Subject: Finding of No Significant Impact (FONSI) for Miscellaneous Sidewalk Improvements, Part II - Chinatown, TMK: 1-7-2, 1-7-3, and 2-1-2, Honolulu, Oahu, Hawaii

**FINAL ENVIRONMENTAL ASSESSMENT FOR CHINATOWN
SIDEWALK IMPROVEMENTS KING STREET
FROM RIVER STREET TO BETHEL STREET
(MISCELLANEOUS SIDEWALK IMPROVEMENTS,
PART II - CHINATOWN)**

**Proposing Agency:
Department of Design and Construction
City and County of Honolulu**

A KING STREET ELEVATION **NOTES:**

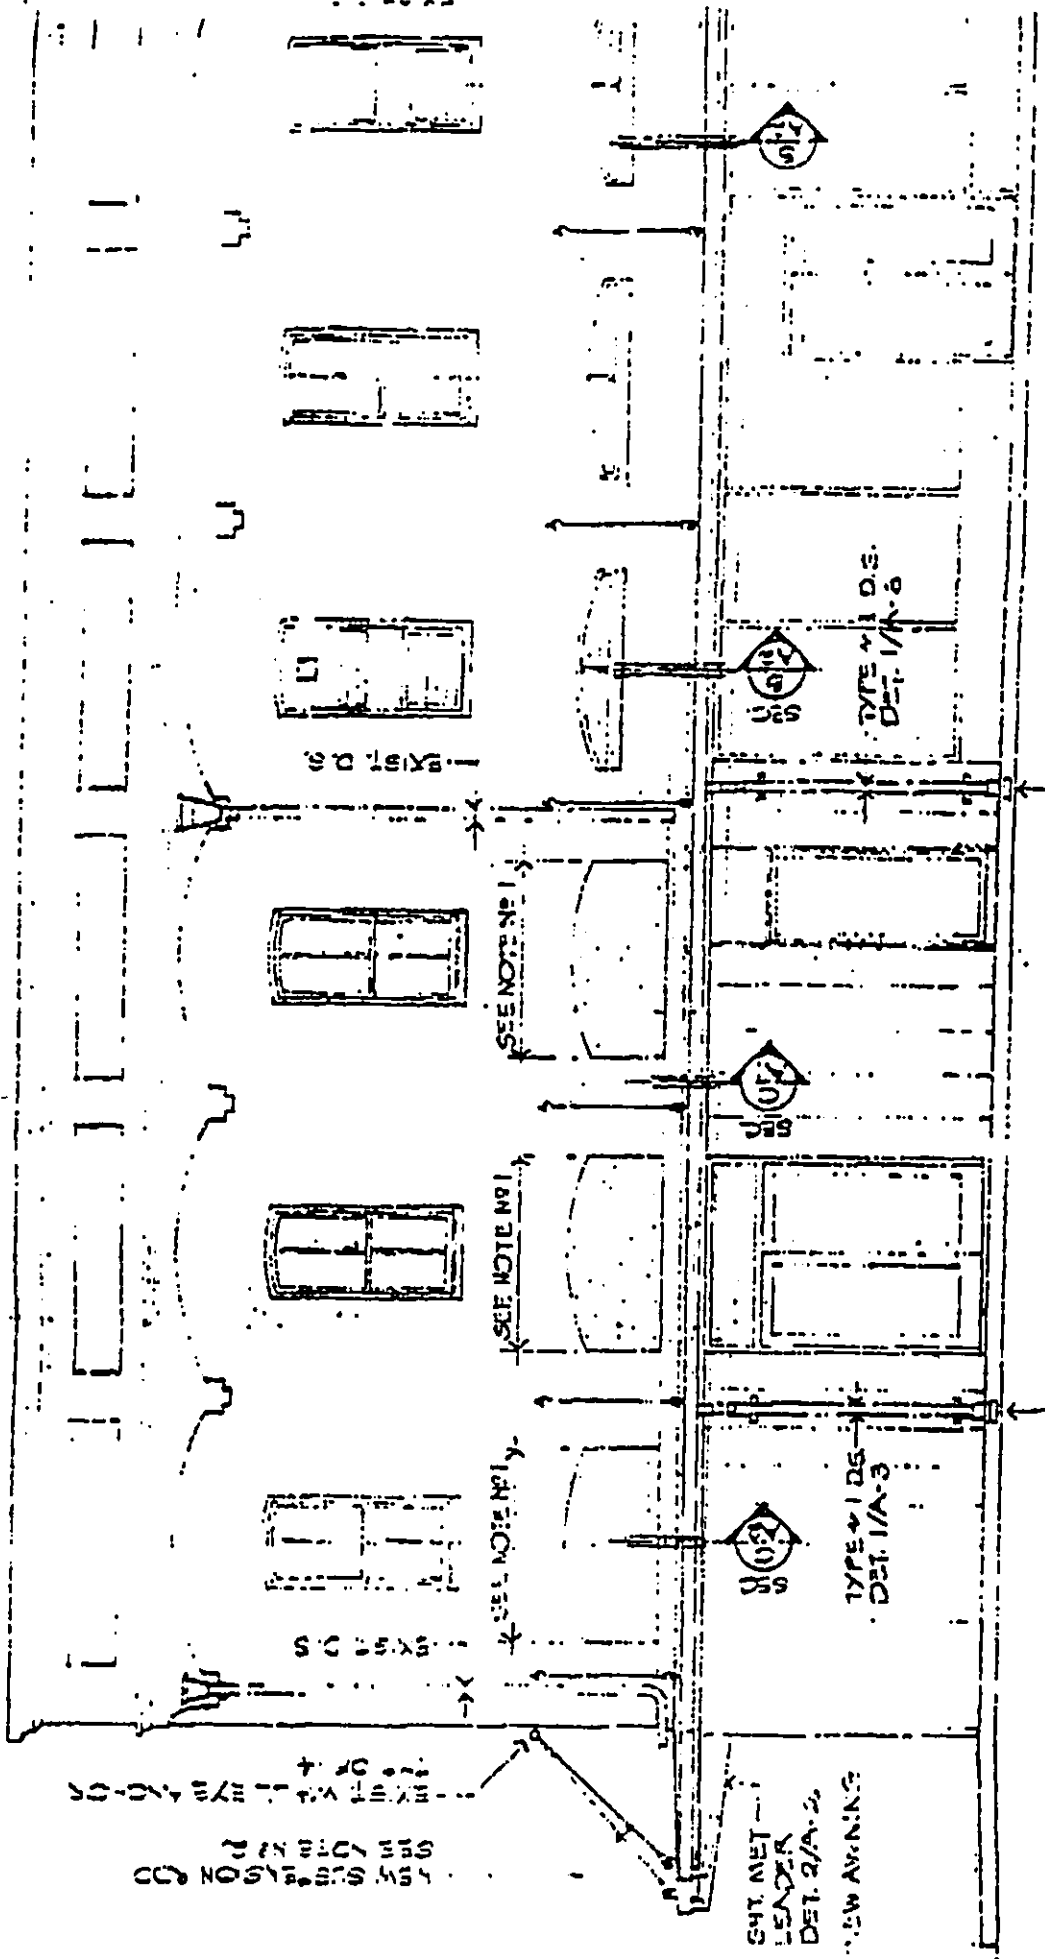
Thank you for the transmittal July 29, 1998 of the proposed replacement of the sidewalk awnings along King and Smith streets. The drawings submitted indicates that the awning will be replaced, in-kind, with a modification at the street corner. We believe that the project should have "no effect" on the historic character of the structure or the Chinatown Special Design District.

Per our telephone conversation this morning, please find attached (via facsimile) the application and partial building elevation for a minor permit (project classified as a minor exterior repair) in the Chinatown Special District. The applicant is proposing to remove and replace the sidewalk awning.
